Ganahl Lumber Project

Final Environmental Impact Report

SCH No. 2019050015

**Volume I:
Responses to Comments**

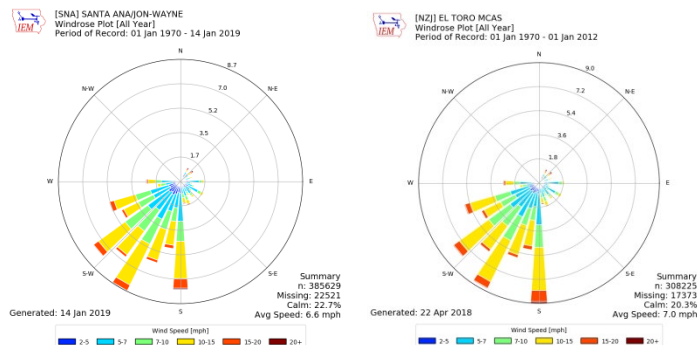
- Section 3.3.3 Circulation and Access: Provide clarification as to whether the proposed signalized driveway will be designed as an intersection at Stonehill Drive that will provide southbound access to the South Coast Water District property.

This comment requests clarification in Section 3.3, Circulation and Access, of the Project Description on whether the proposed signalized driveway will be designed as an intersection at Stonehill Drive that will provide southbound access to the South Coast Water District property.

As described throughout the Draft EIR, the signalized project driveway will be designed and aligned to provide southbound access to the South Coast Water District property. The signalized project driveway will function as an intersection.
